Project	IEEE 802.16 Broadband Wireless Access Working Group < <a href="http://ieee802.org/16">http://ieee802.org/16</a> >	
Title	MS handover to target MR-BS with transparent RS	
Date	2007-05-08	
Submitted		
Source(s)	<p>Kanchei (Ken) Loa, Yi-Hsueh Tsai, Voice: +886-2-2739-9616  Chih-Chiang Hsieh, Yung-Ting Lee, <a href="mailto:loa@iii.org.tw">loa@iii.org.tw</a>  Hua-Chiang Yin, Shiann-Tsong Sheu,  Frank C.D. Tsai, Youn-Tai Lee,  Heng-Iang Hsu  Institute for Information Industry  8F., No. 218, Sec. 2, Dunhua S. Rd.,  Taipei City, Taiwan.</p> <p>[add co-authors here]</p>	
Re:	IEEE 802.16j-07/013: "Call for Technical Comments Regarding IEEE Project 802.16j"	
Abstract	This contribution proposes procedures for network topology advertisement in MR system	
Purpose	Text proposal for 802.16j Baseline Document	
Notice	<p>This document has been prepared to assist IEEE 802.16. It is offered as a basis for discussion and is not binding on the contributing individual(s) or organization(s). The material in this document is subject to change in form and content after further study. The contributor(s) reserve(s) the right to add, amend or withdraw material contained herein.</p>

# MS handover to ta

Figure xxx –Network topology advertisement in transparent RS system

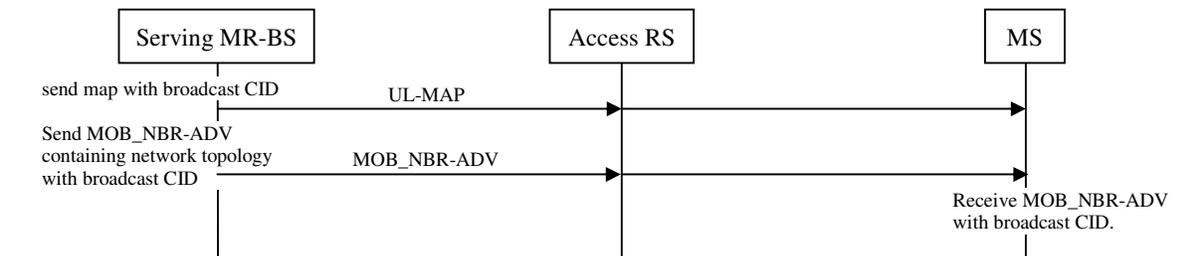
The MR-BS and the RS shall broadcast information about the infrastructure stations that are present in the network using the MOB\_NBR-ADV message defined in 6.3.2.3.47. The MR-BS and the RS may obtain the information to be included in the MOB\_NBR-ADV message over the backbone network or over the relay links. Each non-transparent RS can broadcast a different MOB\_NBR-ADV message that is suitable for its service area. For transparent RS, the MOB\_NBR-ADV message shall be broadcasted by the MR-BS depicted in Figure xxx.

Figure yyy – Network advertisement in non-transparent RS system with centralized scheduling

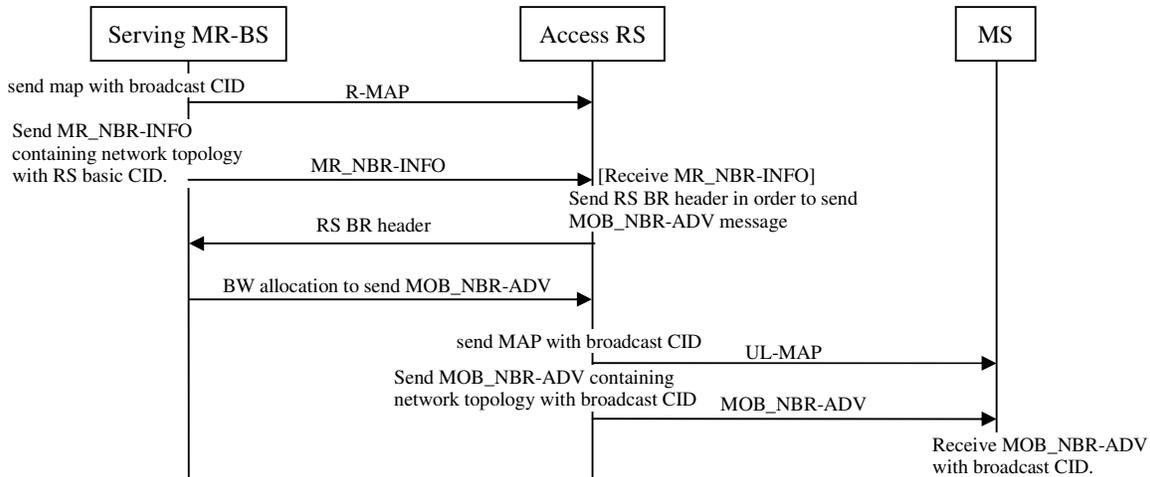
To facilitate each non-transparent RS to transmit a MOB\_NBR-ADV message suitable for its service area, the MR-BS shall transmit a MR\_NBR-INFO message to the RSs. The MR\_NBR-INFO is a customized, unicast message that is composed by the MR-BS according to the specific neighborhood of the receiving RS. The MR\_NBR-INFO message is transmitted by the MR-BS to the RSs over the relay links. In order to compose the MR\_NBR-INFO customized for the subordinate RSs, the MR-BS can use location information or the interference measurement reports received from the infrastructure stations. Under centralized scheduling, as shown in Figure yyy, the RS shall request bandwidth on the access link to broadcast MOB\_NBR-ADV. Under distributed scheduling, as shown in Figure zzz, the RS shall autonomously broadcast MOB\_NBR-ADV on the

An RS, depending on its capability and depending on the messages that it receives, can choose between one of the following options in generating the MOB\_NBR-ADV message:

- (a) An RS can broadcast the MOB\_NBR-ADV message without modifying the neighbor list of the MR\_NBR-INFO message, received from the MR-BS.
- (b) An RS can further customize and compose a MOB\_NBR-ADV message that is suitable for its service area by utilizing the information present in the MR\_NBR-INFO messages received from the MR-BS.
